**Re: Hoffmantown West Church, 6440 Coors Blvd. NW**  
**Approval of Permanent Certificate of Occupancy (C.O.)**  
**Engineer's Stamp dated 08/24/06 (D-17/D93)**  
**Certification dated 05/22/07**

**Re: Hoffmantown West Church  
Grading and Drainage Plan  
Engineer's Stamp dated 8-29-06 (D12-D1)**

Re: Drainage Report for Hoffmantown West Church, ZAP D-12  
Engineer's Stamp Dated March 28, 2005

**Re: Hoffmantown West Church Drainage Report**  
**Engineer Stamp date 12-28-05 (D12/D1)**

**MAP POCKET B**  
**Proposed Basin Map**

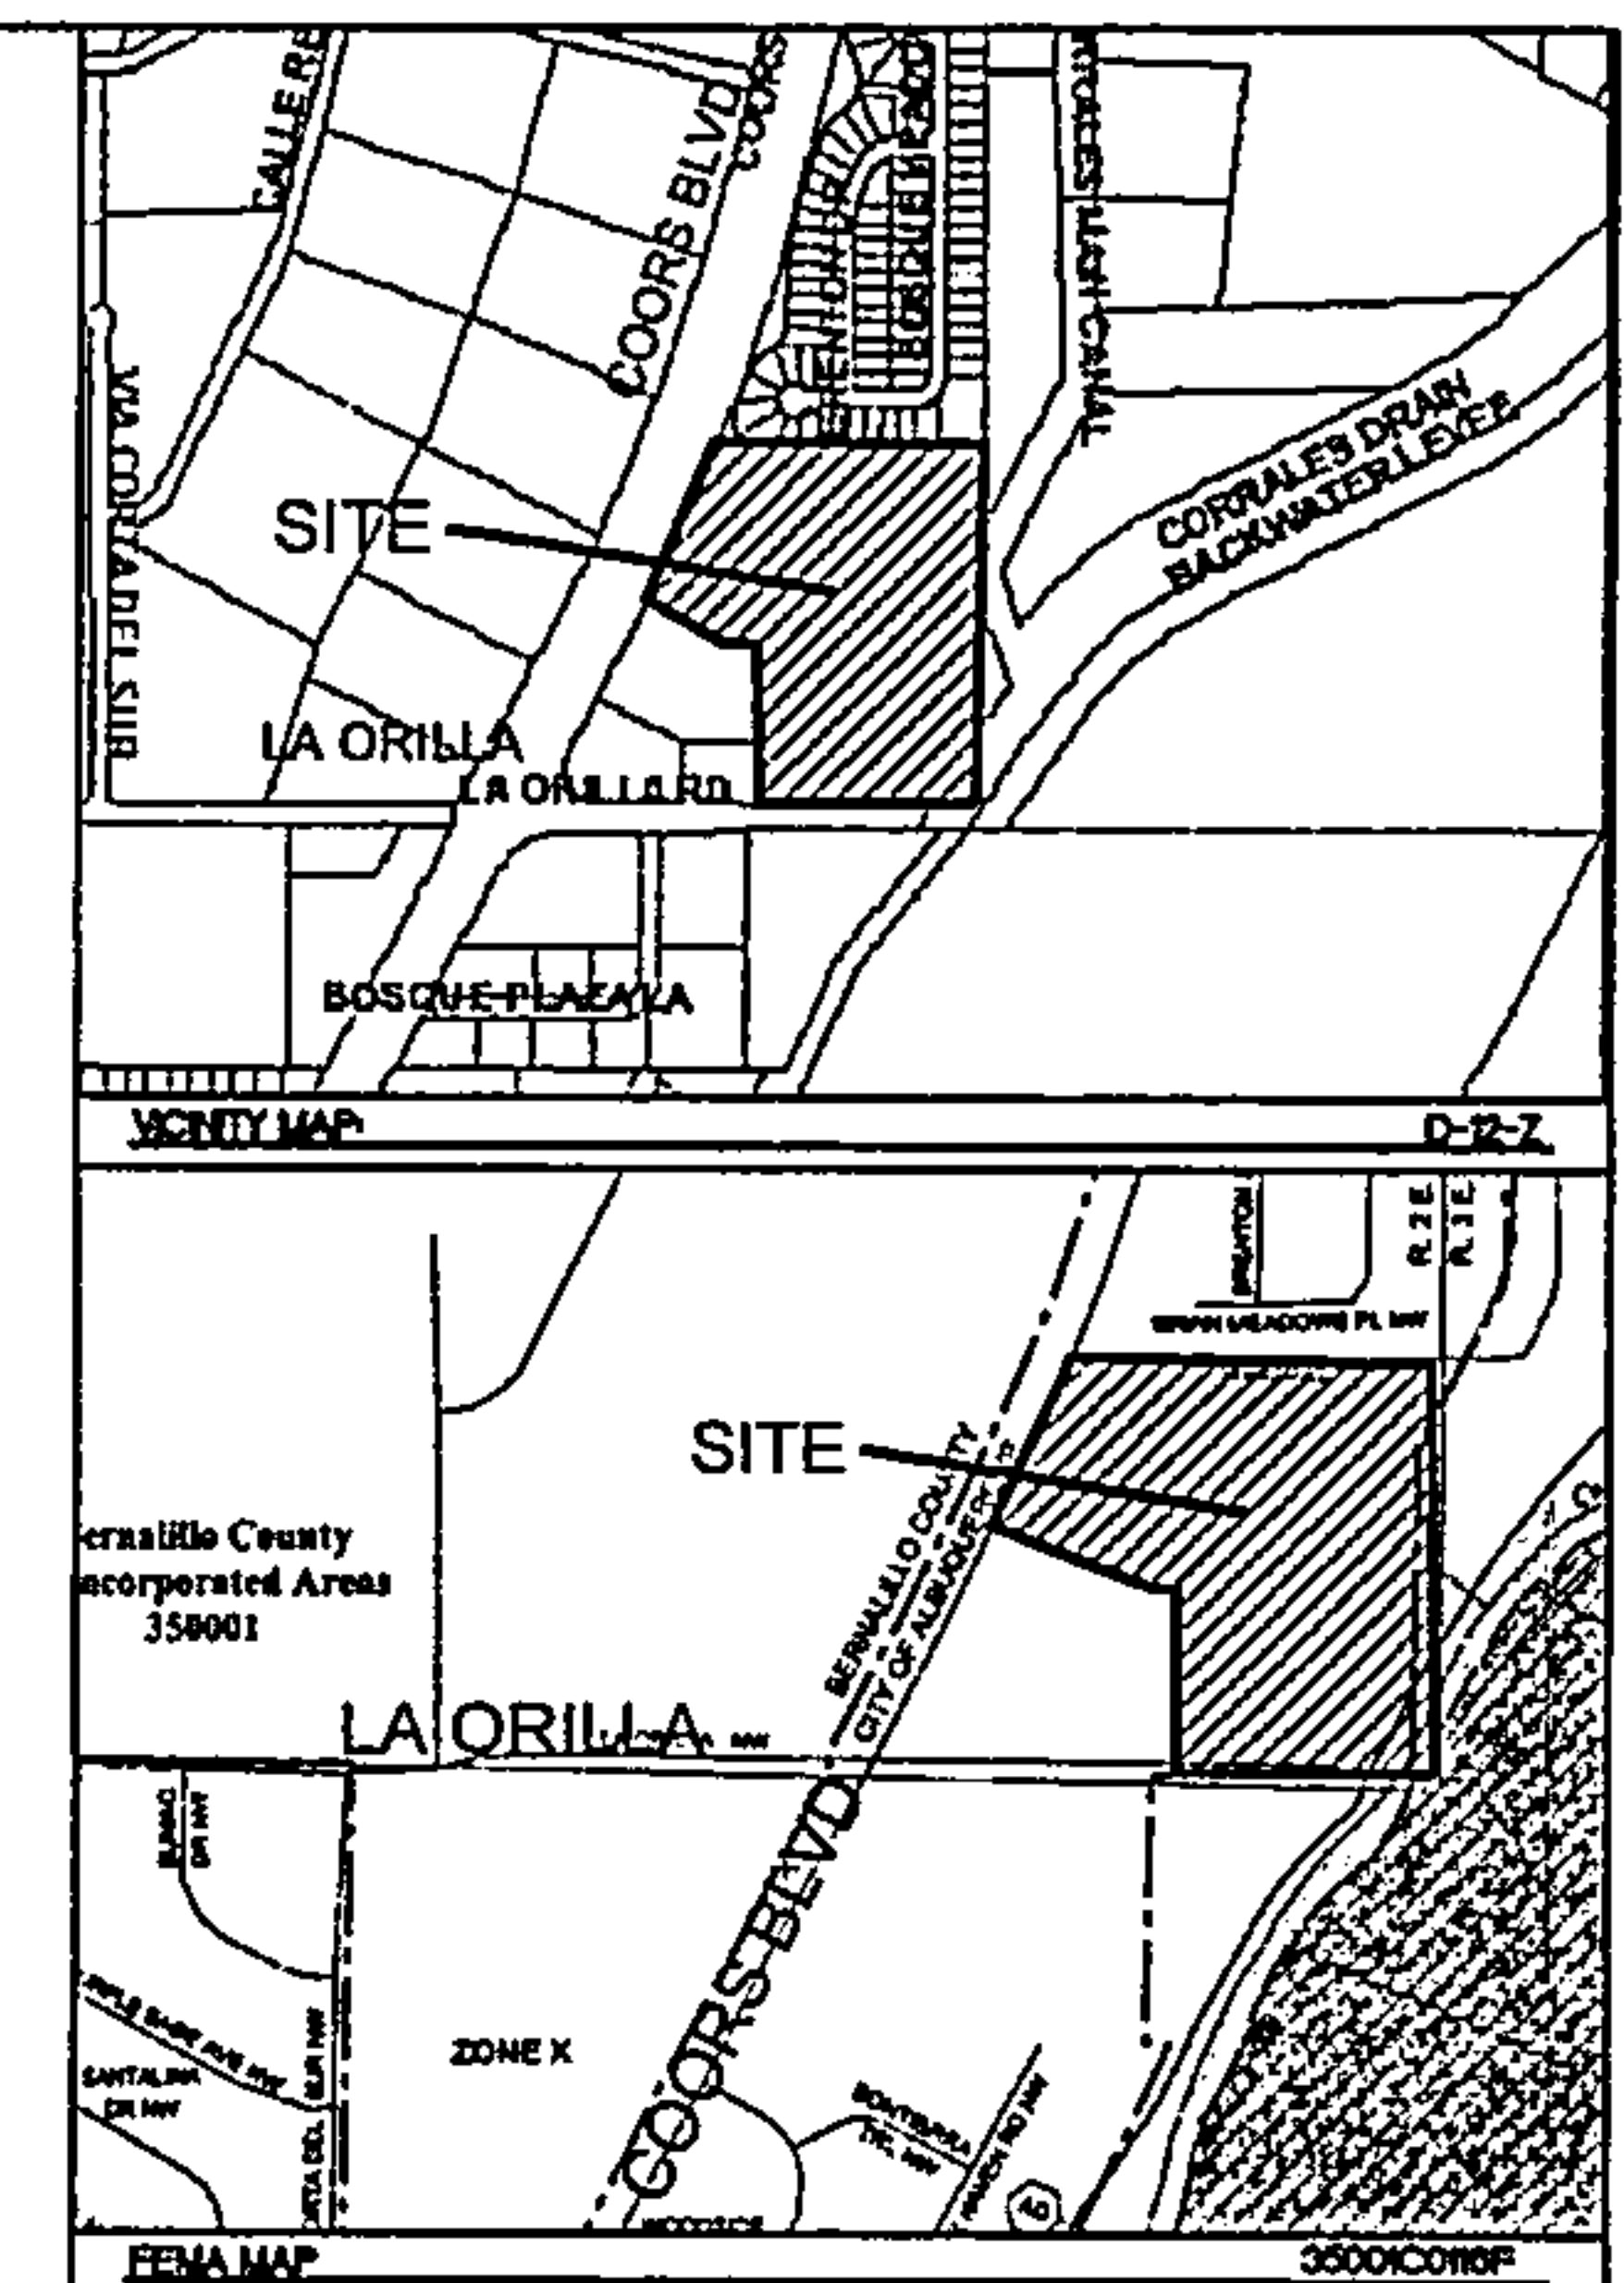
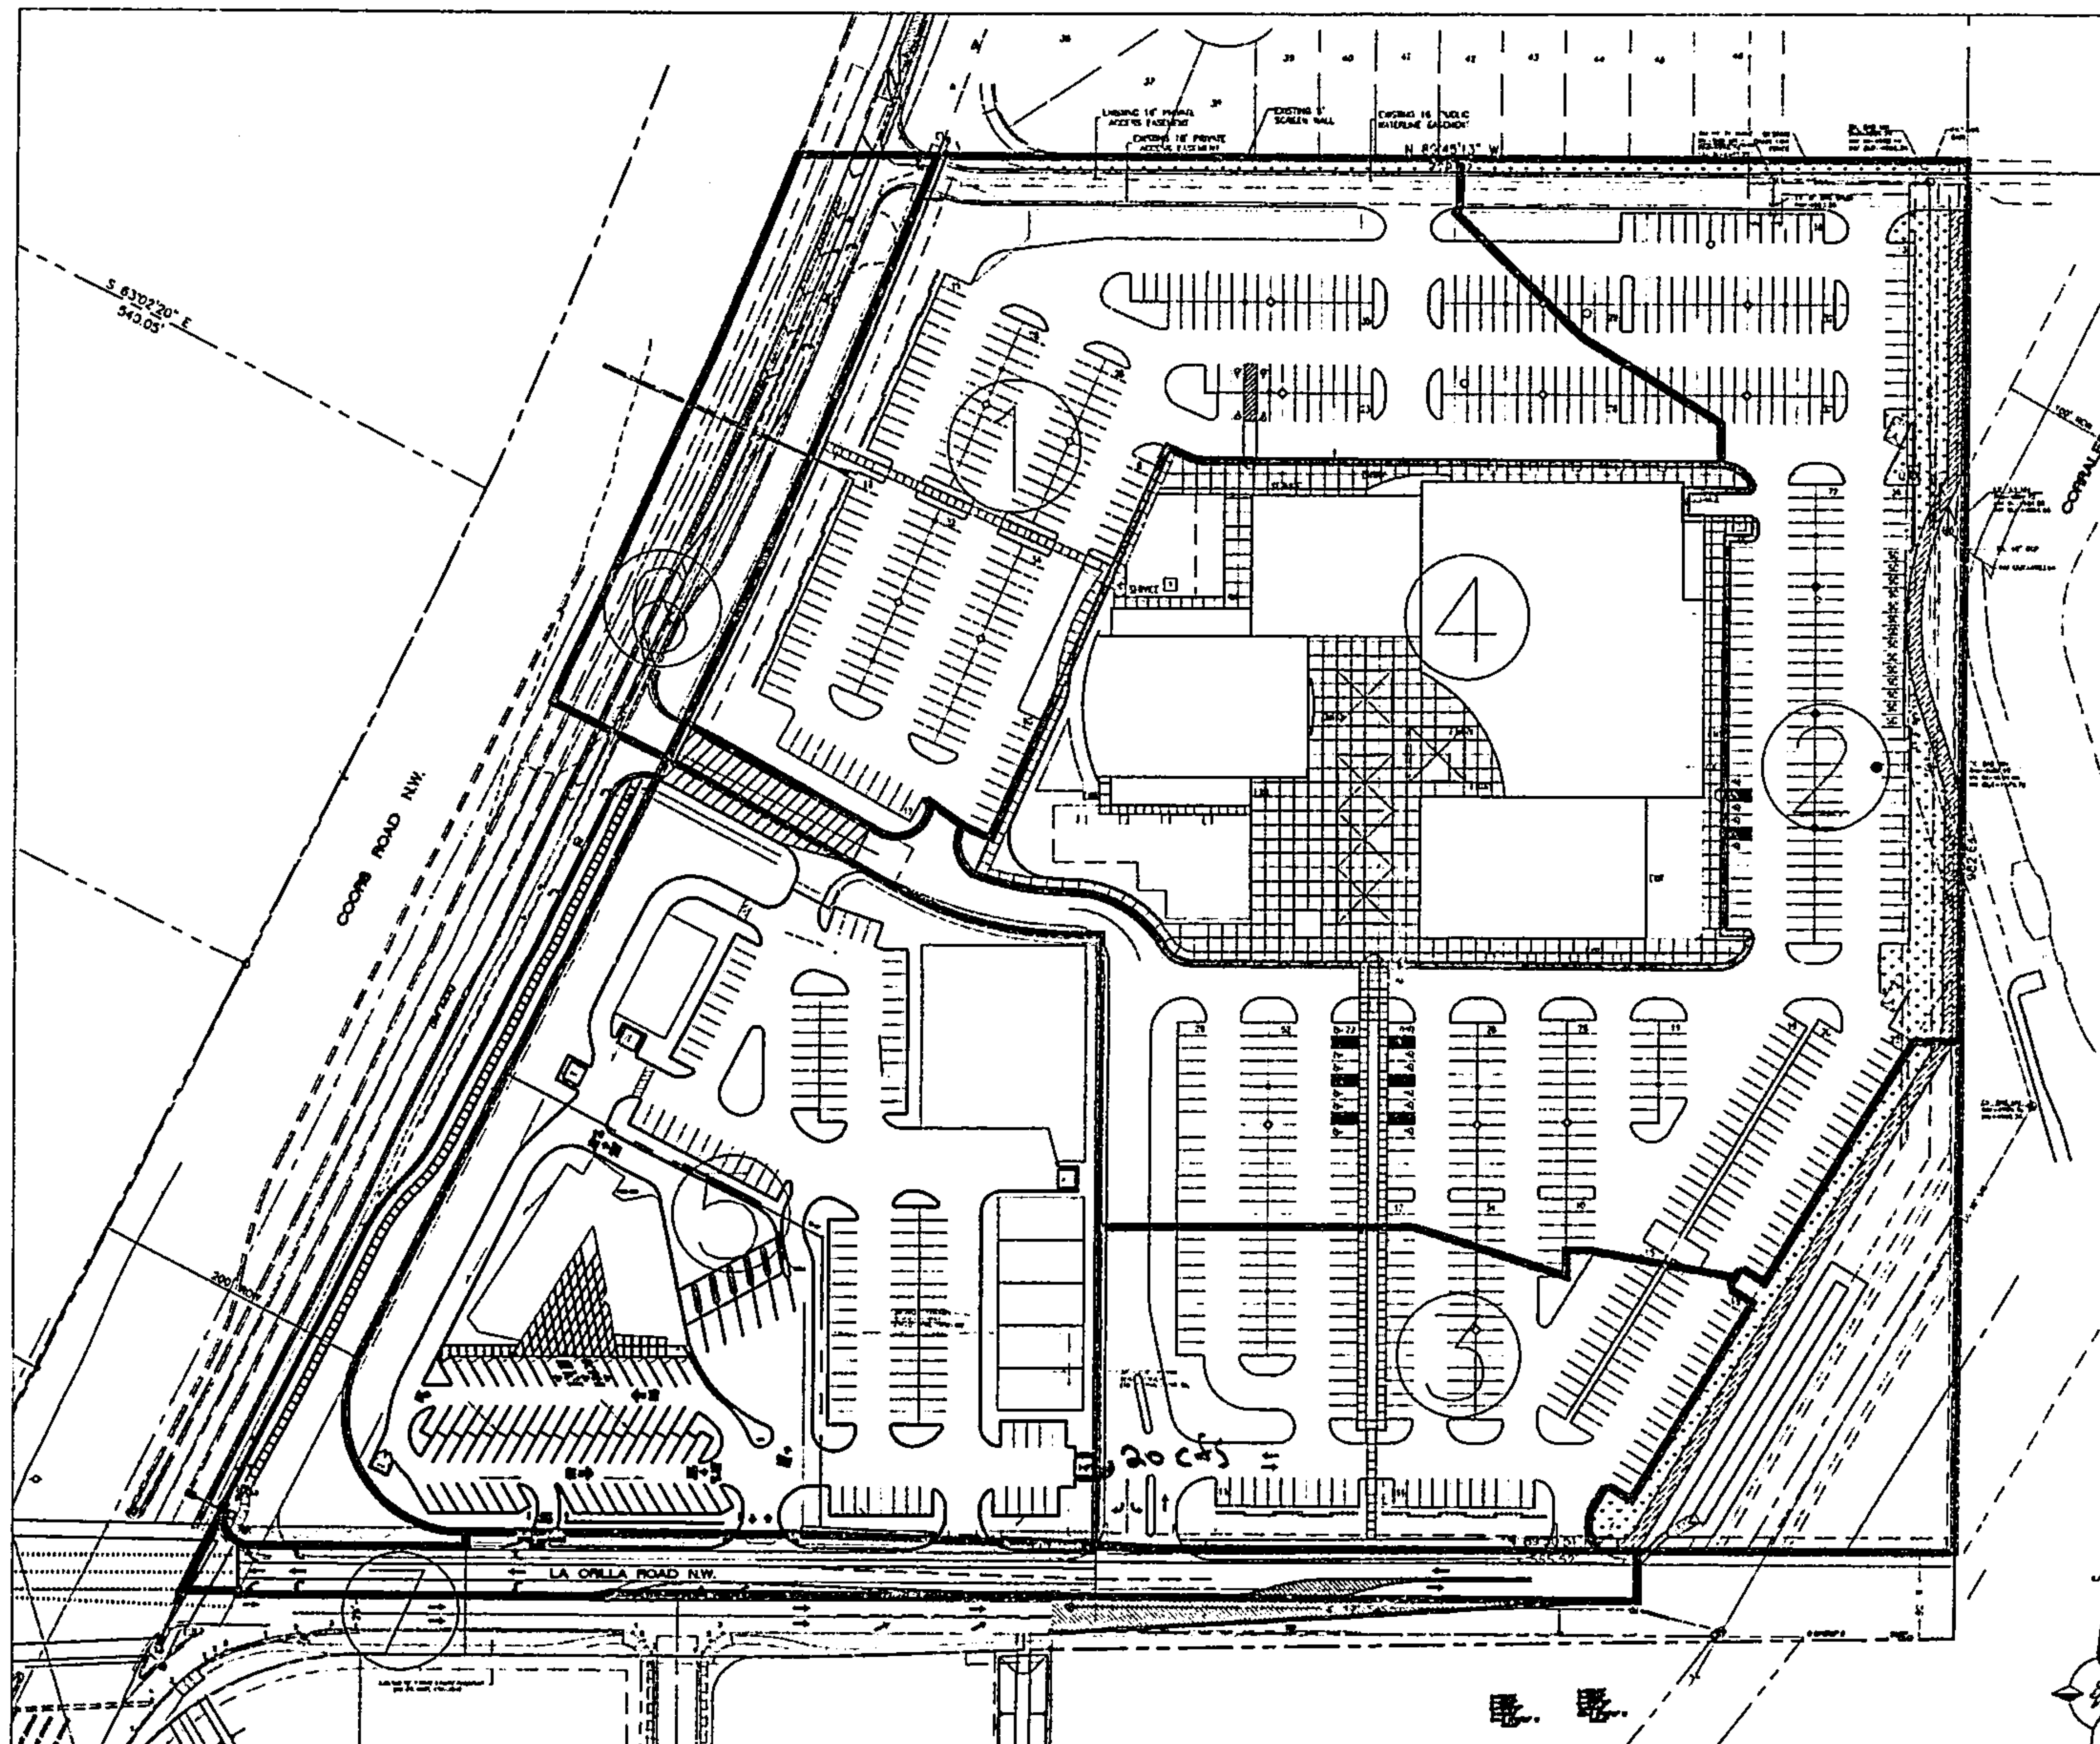
A separate grading plan should be submitted for subsequent Building Permit approvals as it is difficult to see where the building is on the certification submitted and will help with grading adjacent to the structure.
